ITEM 9.1.3
APPENDIX A

Flood Mapping

SCHEDULE OF SUBMISSIONS

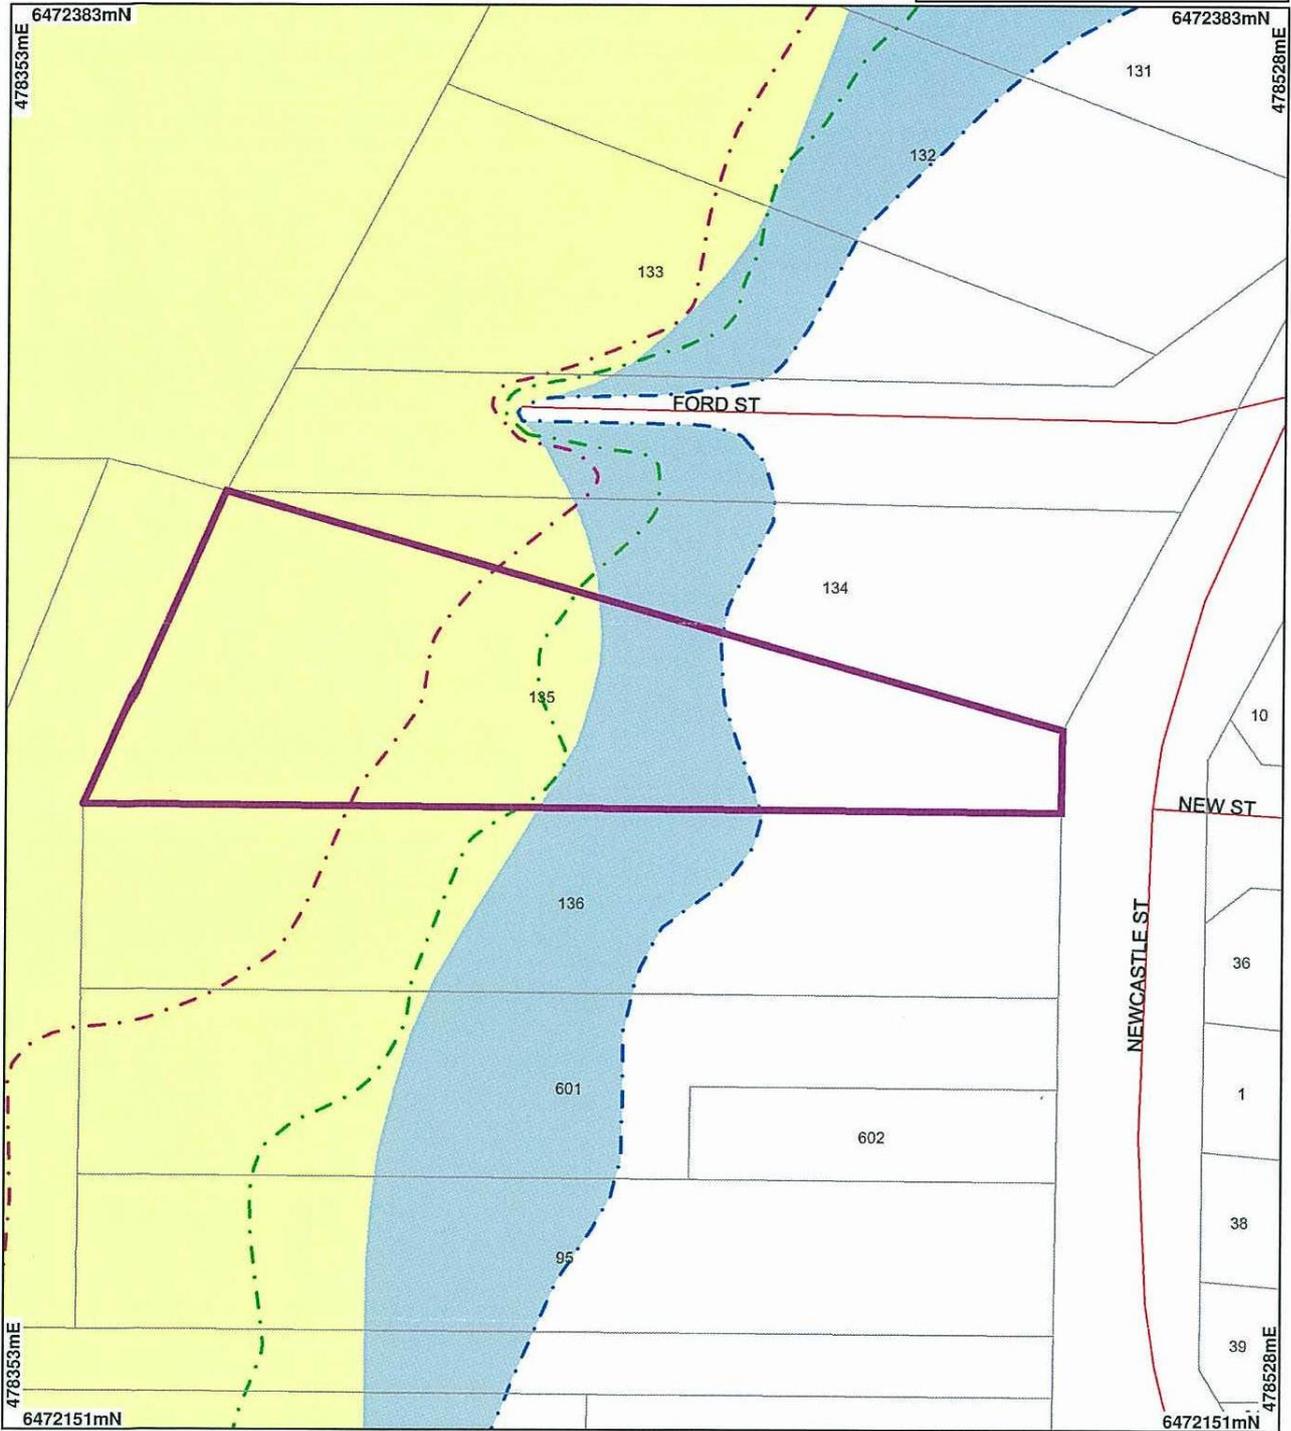
2.	Department of Water	-	<p>The Department of Water, in carrying out its role in floodplain management, provides advice and recommends guidelines for development on floodplains with the object of minimising flood risk and damage.</p> <p>The Avon River Flood Study through York shows that a large portion of the Lot is affected by major flooding during major events with the following flood levels expected:</p> <p>10 year ARI 172.1 m AHD 25 year ARI 172.8 m AHD 100 year ARI 174.0 m AHD</p> <p>Our existing floodplain management strategy for the area states:</p> <ul style="list-style-type: none"> Proposed development (ie, filling, building, etc) that is located outside of the floodway is considered acceptable with respect to major flooding. However, a minimum habitable floor level of 174.5 m AHD is recommended to ensure adequate flood protection. 	<p>The floodway is identified by the yellow shading on the Department of Water's map.</p> <p>It is recommended that a condition be imposed preventing filling within the identified floodway area.</p>

<ul style="list-style-type: none"> Proposed development (ie, filling, building, etc) that is located within the floodway and is considered obstructive to major flows is not acceptable as it would increase flood levels upstream. No new buildings are acceptable in the floodway. <p>Consequently, the proposal to fill a portion of the Lot is considered acceptable with regard to major flooding, provided the fill does not encroach into the floodway.</p> <p>Map provided (see Appendix 2).</p>
